DRAWN: CHEN	DATED: SOCT02	COMPANY: ARTCOM LIMITED		
		TITLE: ARTCOM RF MODULE(BASE)		
CHECKED:	DATED:	PCB FILE: 2G4WBMX3.job		
		L O O J O O		
QUALITY CONTROL:	DATED:	SCALE:	SIZE: A3	REV: 0
		CODE:	DRAWING NO:	SHEET: 1 OF 1
RELEASED:	DATED:

COMPANY: ARTCOM LIMITED			
TITLE: C600 HANDSET			
FLAG:			
L	1	0	PCB FILE: C600xxxxxxxx
J	B	0	
SCALE:		SIZE: A3	REV: 0
DRAWING NO:		SHEET: 1 OF 4

DRAWN: CHEN	DATED: SOCT02	COMPANY: ARTCOM LIMITED		
		TITLE: ARTCOM RF MODULE(HANDSET)		
CHECKED:	DATED:	PCB FILE: 2G4WHMX2.job		
		L O O J O O		
QUALITY CONTROL:	DATED:	SCALE:	SIZE: A3	REV: 0
		CODE:	DRAWING NO:	SHEET: 1 OF 1
RELEASED:	DATED:

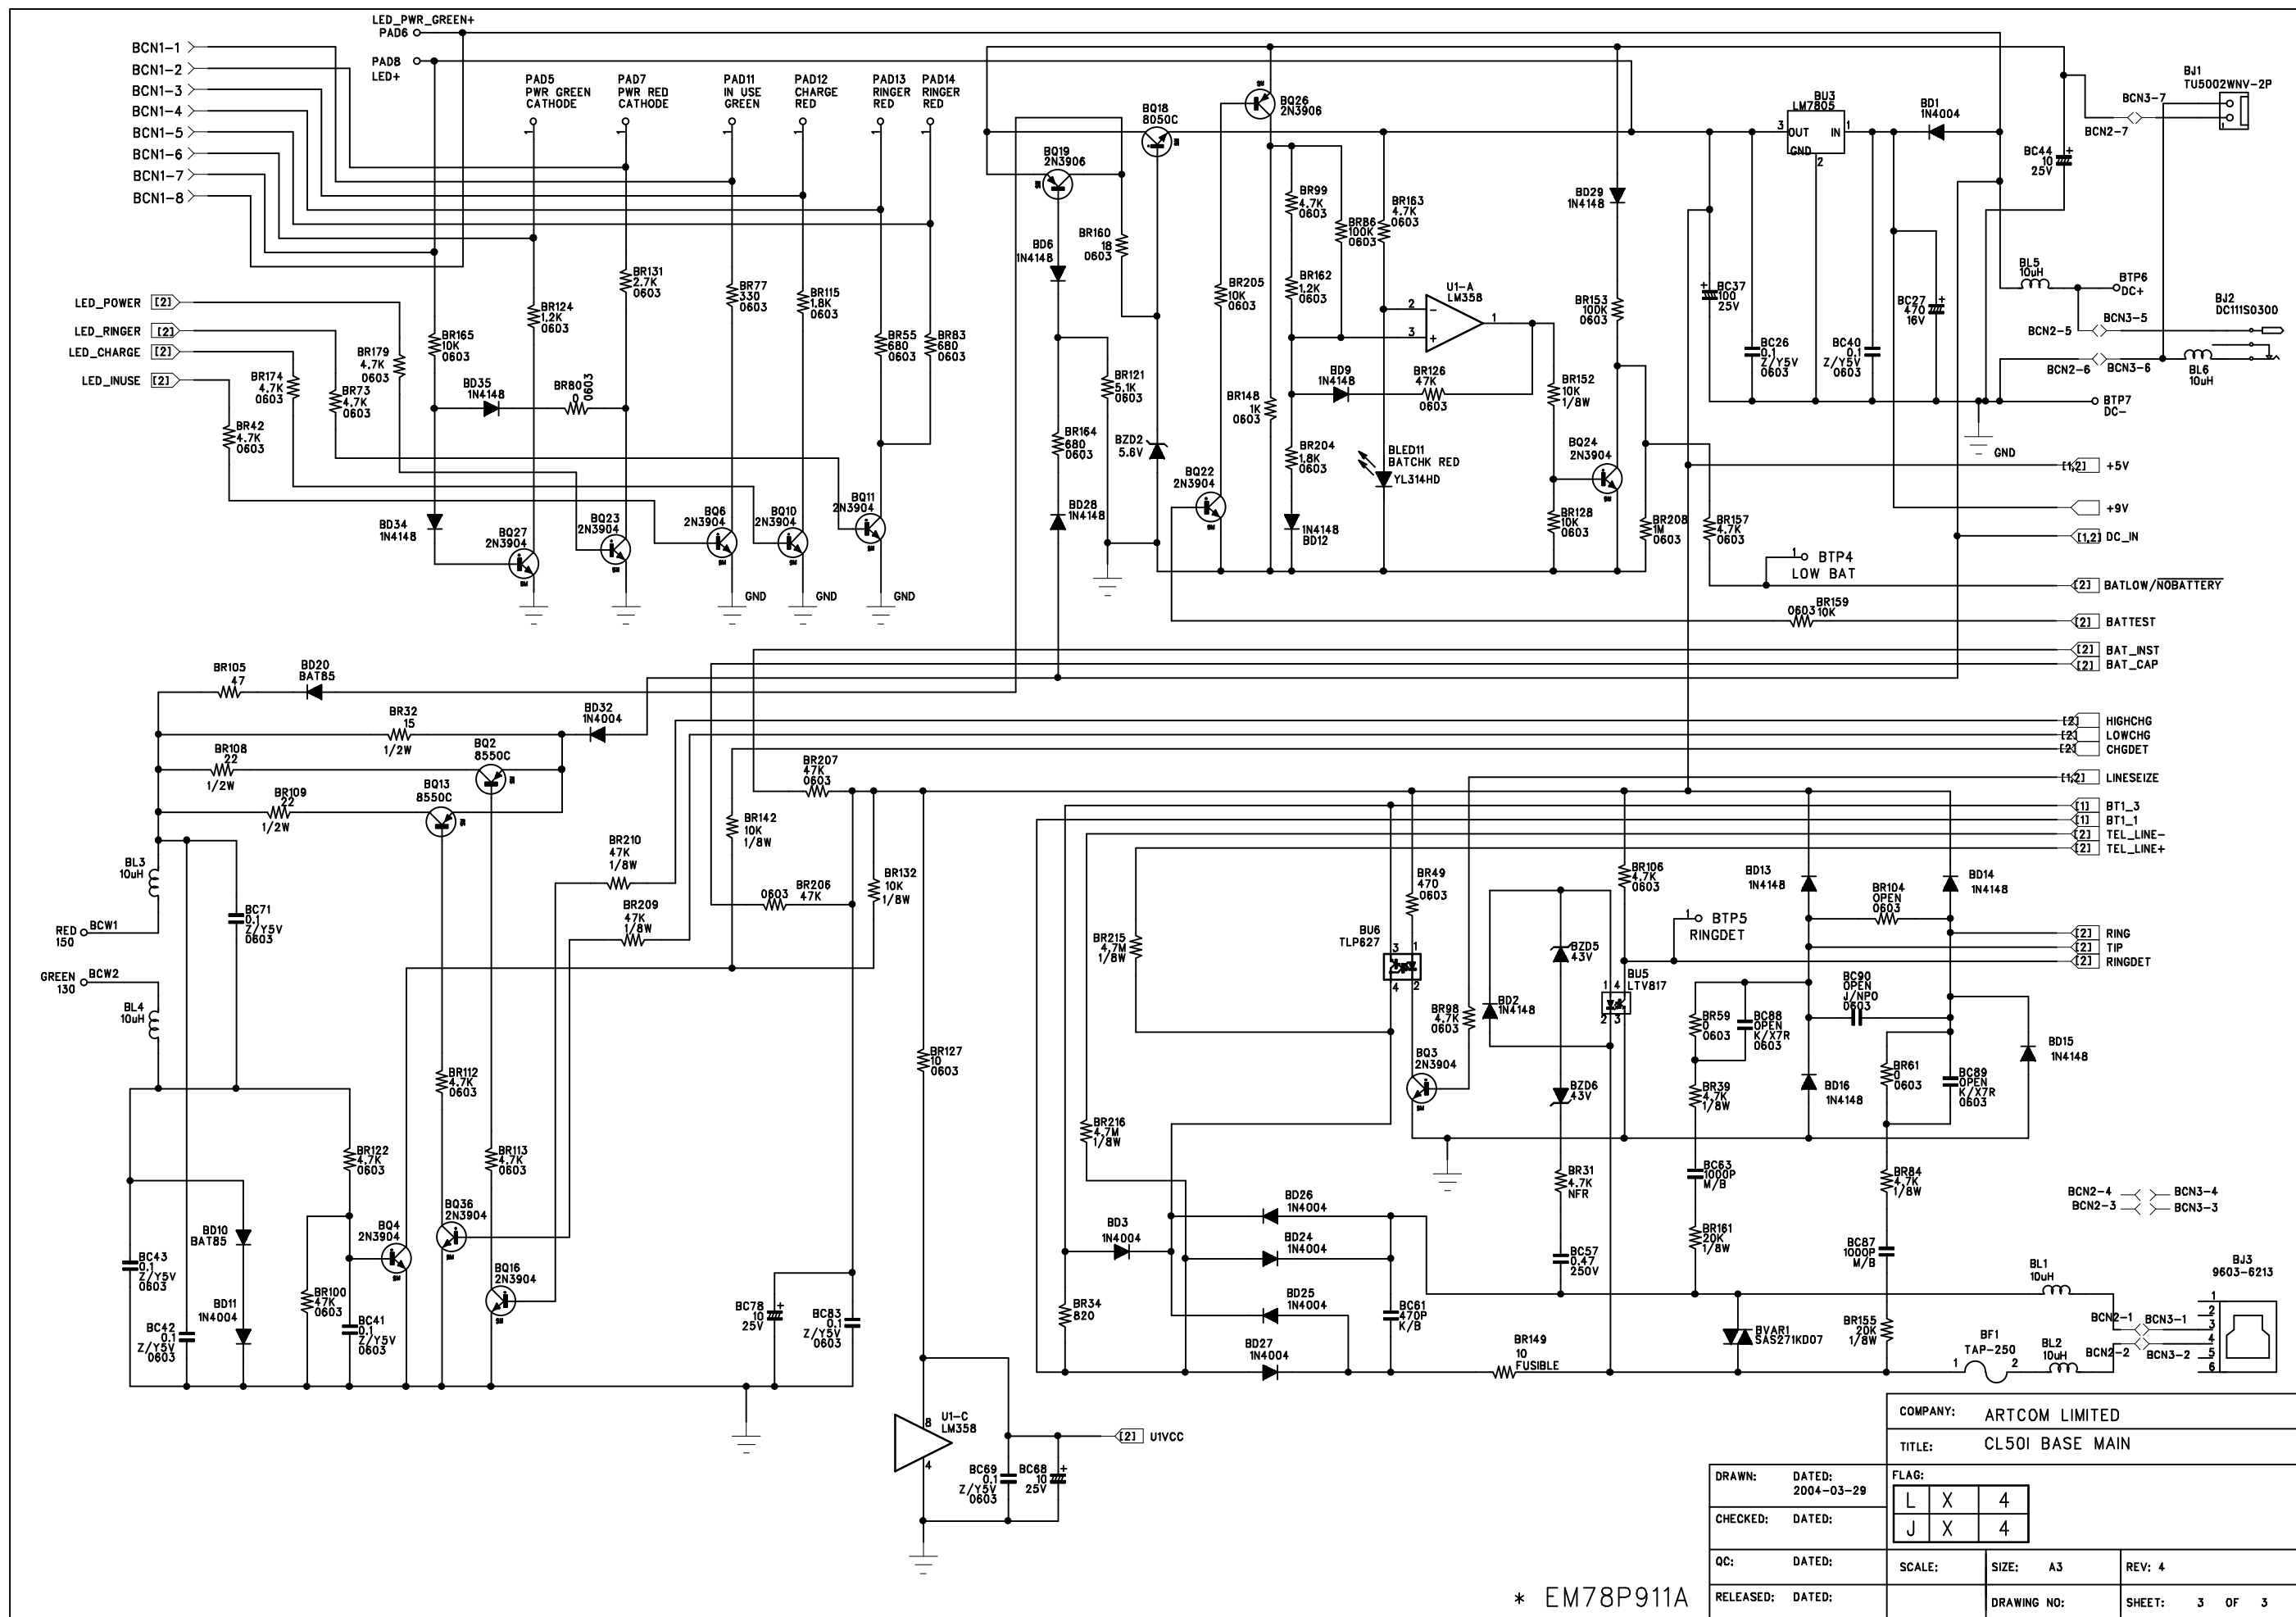
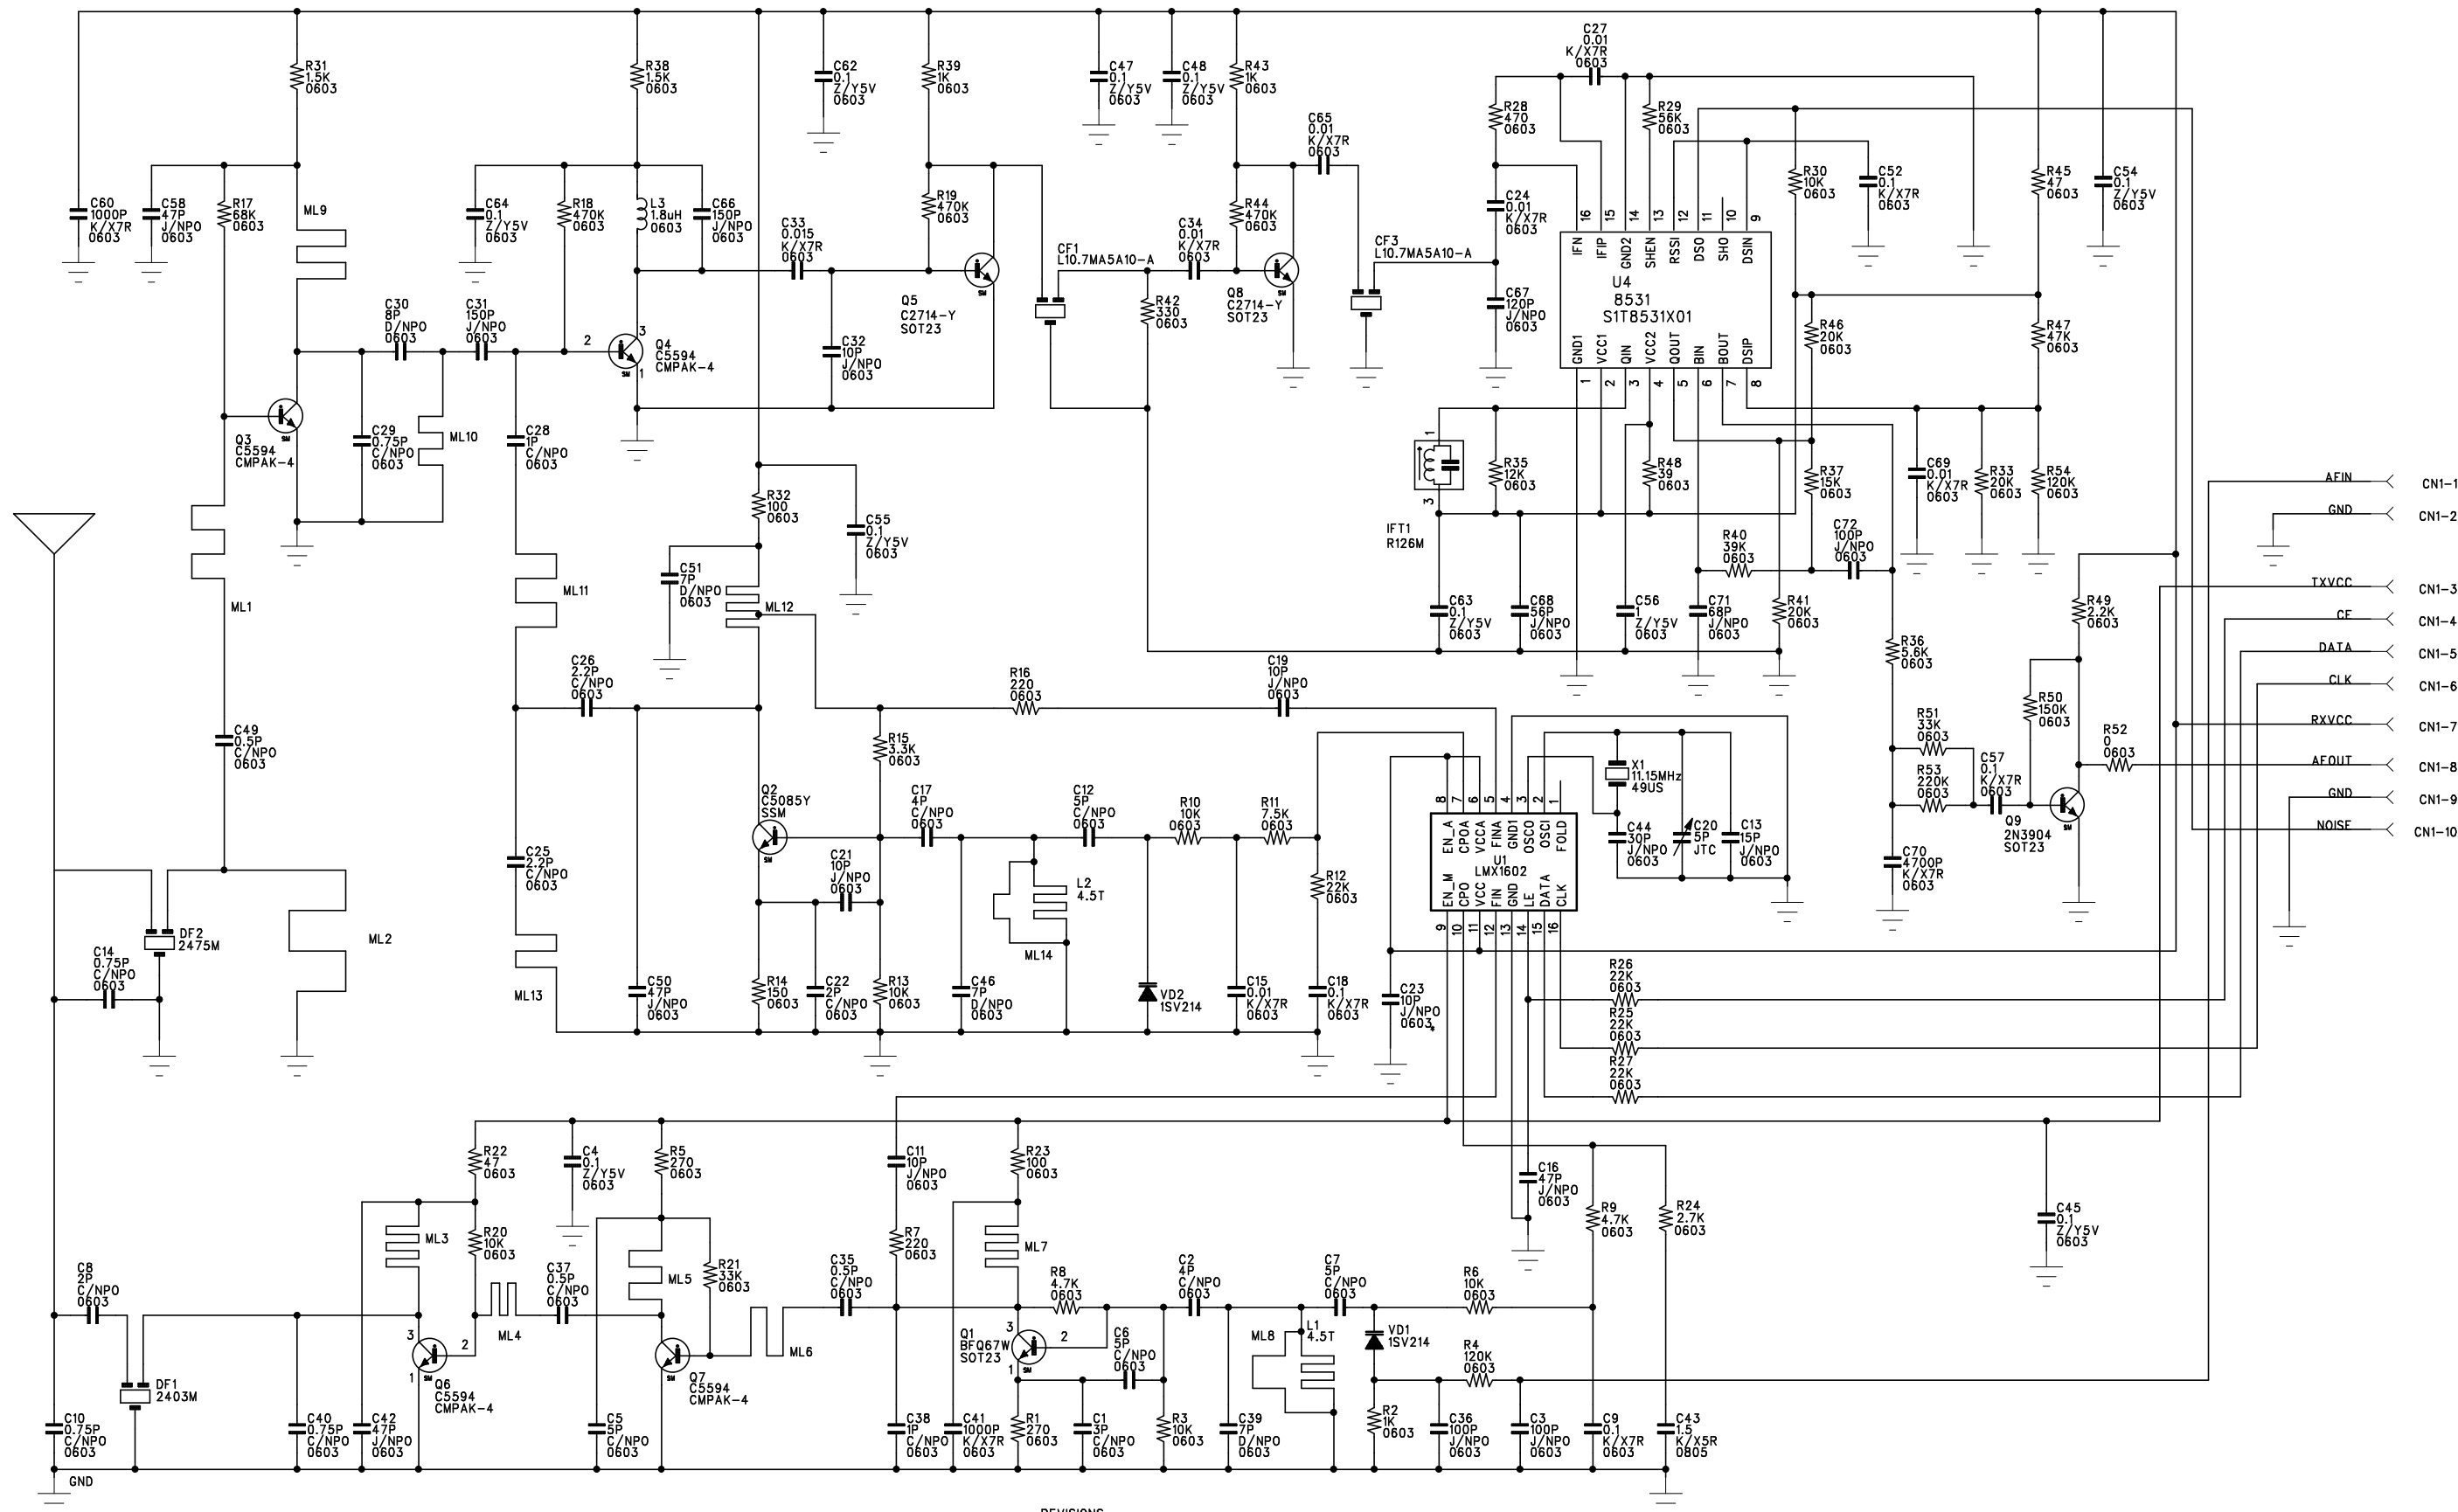
REVISIONS
ECN 02/05/02
1. C12 5P CHANGE TO 6P
2. C17 3P CHANGE TO 4P
3. C44 20P CHANGE TO 24P
ECN 04/13/02
1. VD1 VD2 KDV154C CHANGE TO 1SV214
ECN 04/18/02
1. C51 2.2P CHANGE TO 7P
ECN 04/24/02
1. C12 6P CHNAGE TO 5P

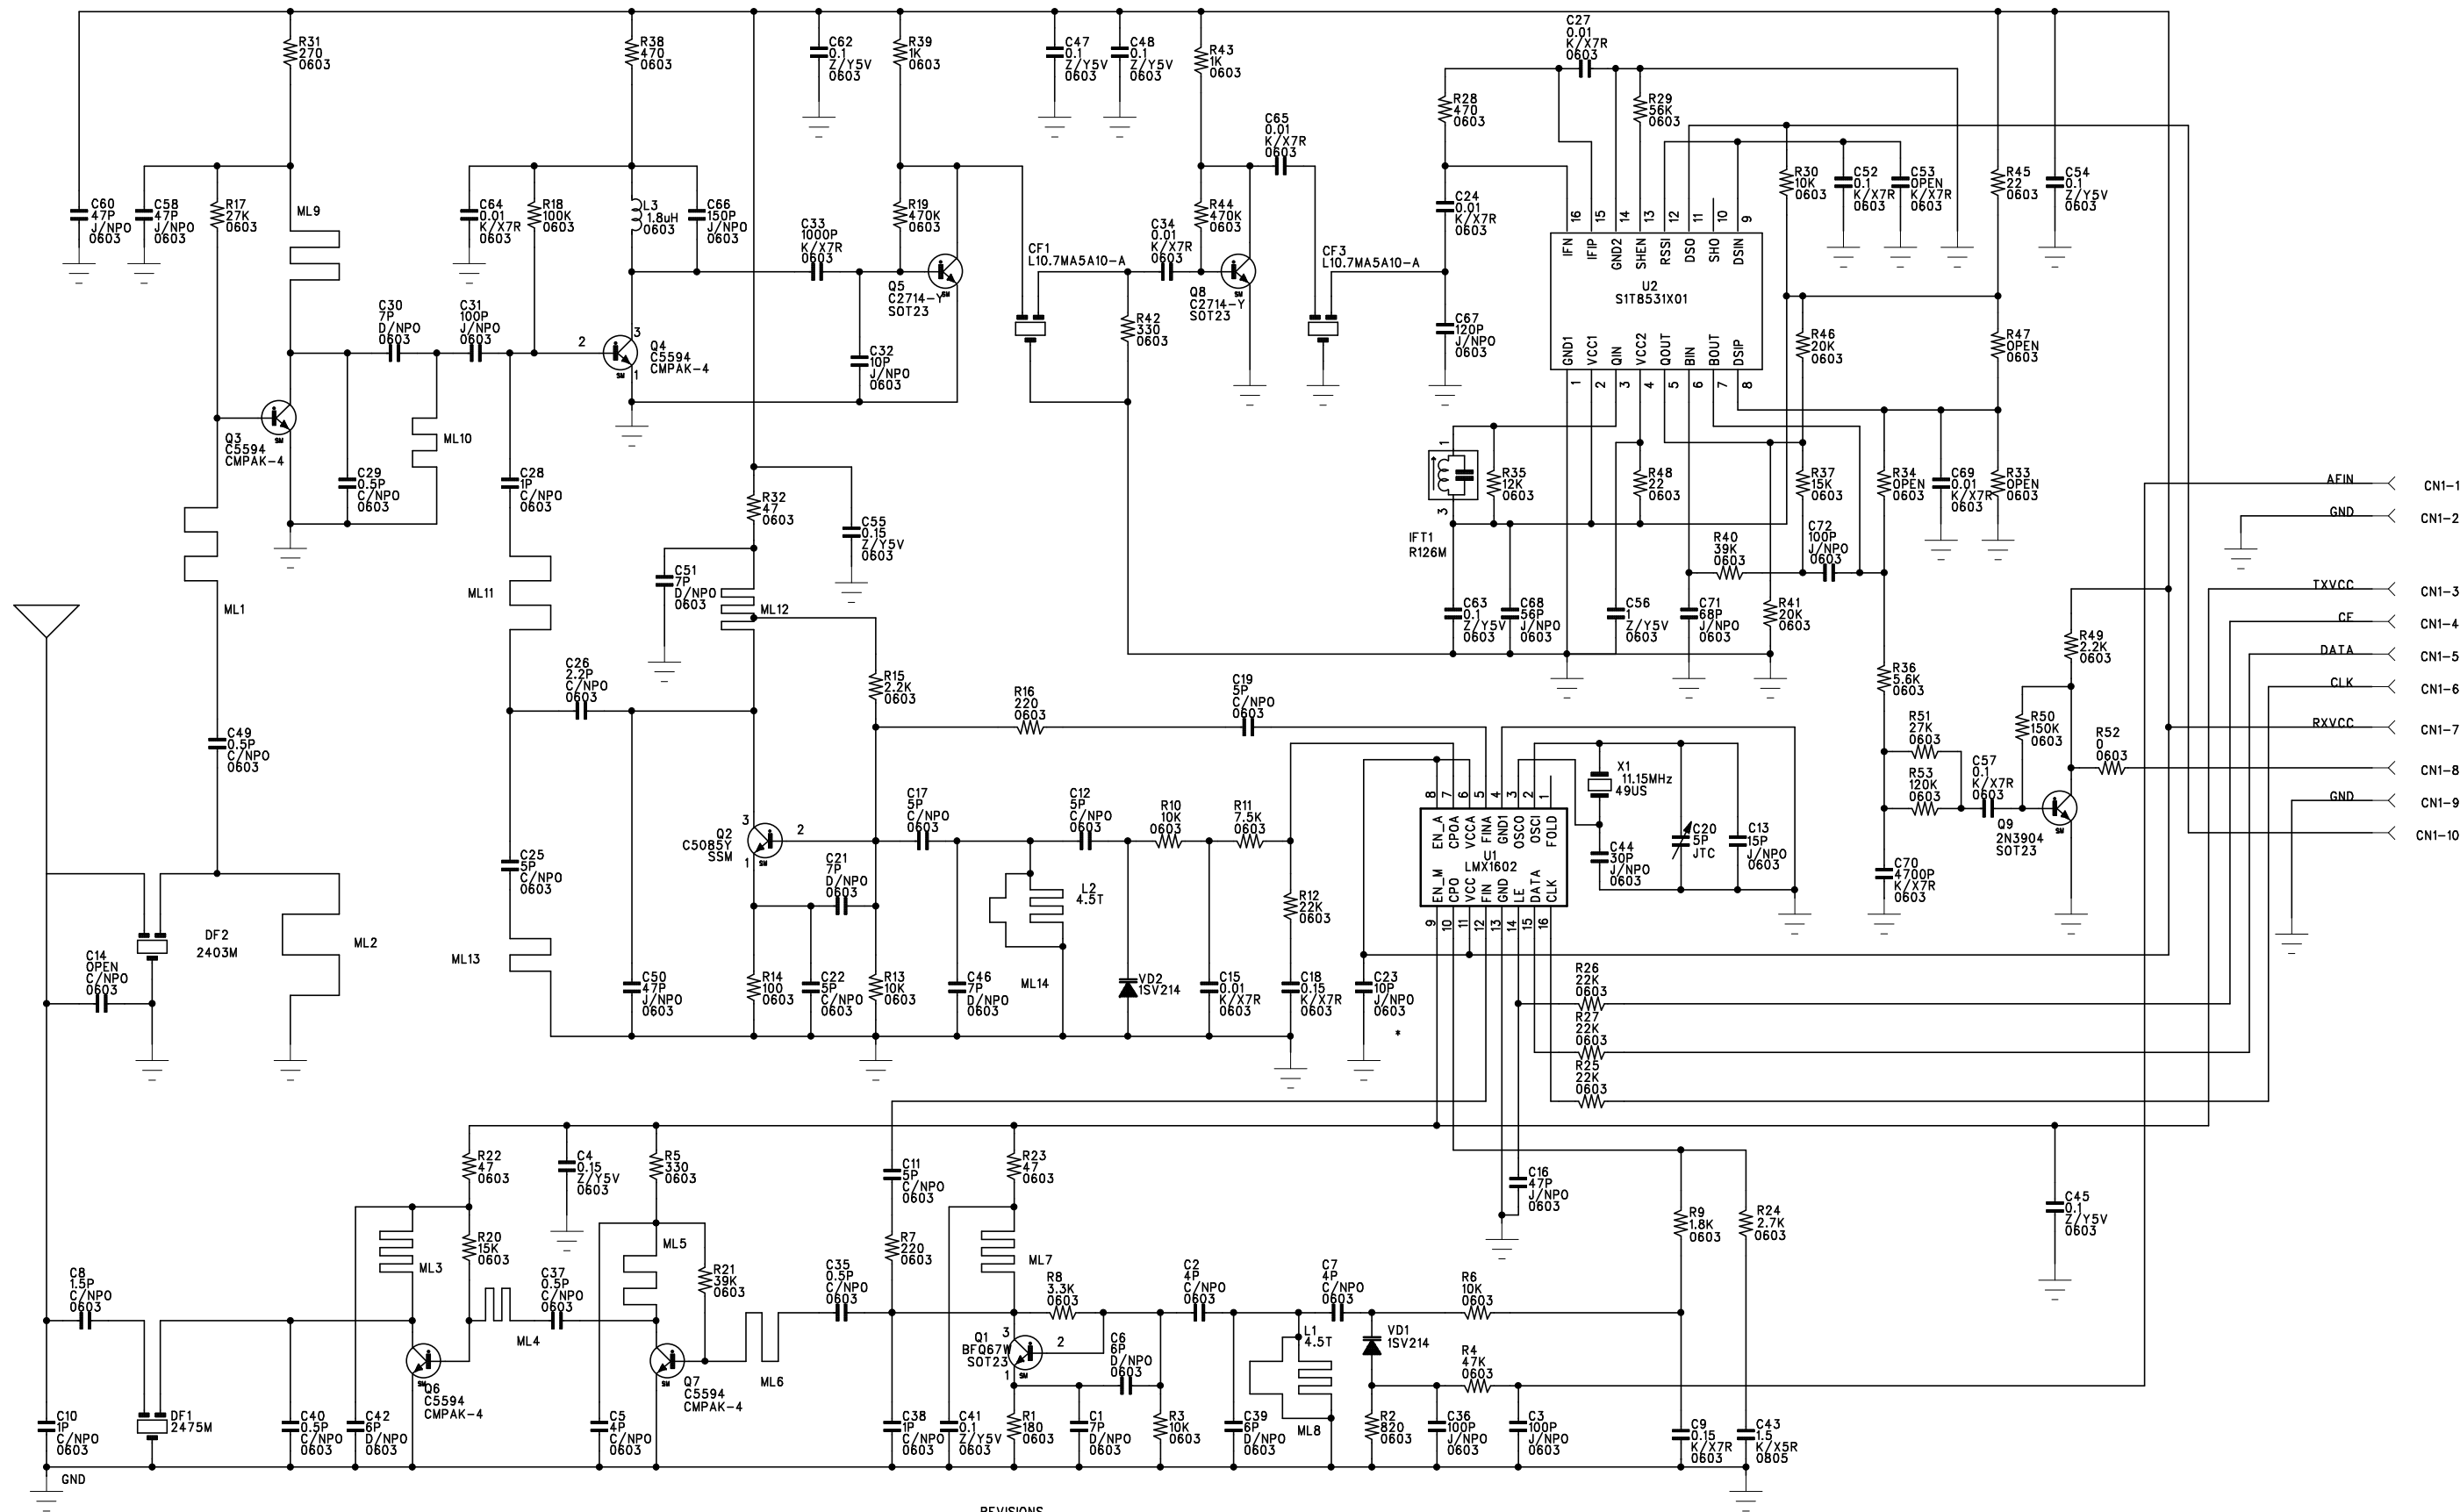
REVISIONS
ECN 02/05/02
1. C12 4P CHANGE TO 5P
2. C44 20P CHANGE TO 24P
ECN 04/13/02
1. VD1 VD2 KDV154C CHANGE TO 1SV214
ECN 04/18/02
1. C51 3P CHANGE TO 7P
